Sheet: /
File: Arduino.sch

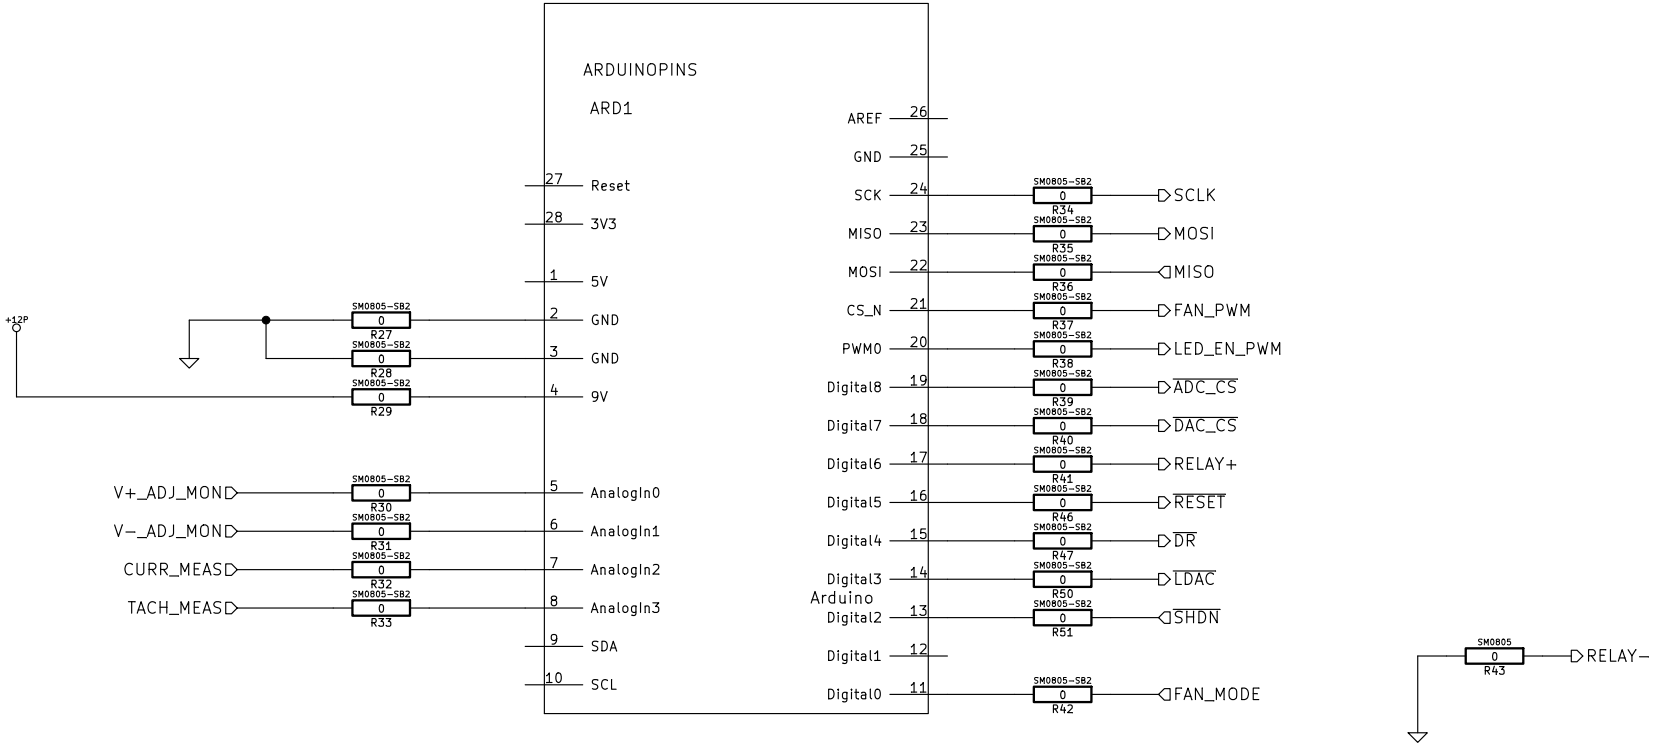
The signal Digital5 was skipped so the pin numbers for all the following pins are off by one.
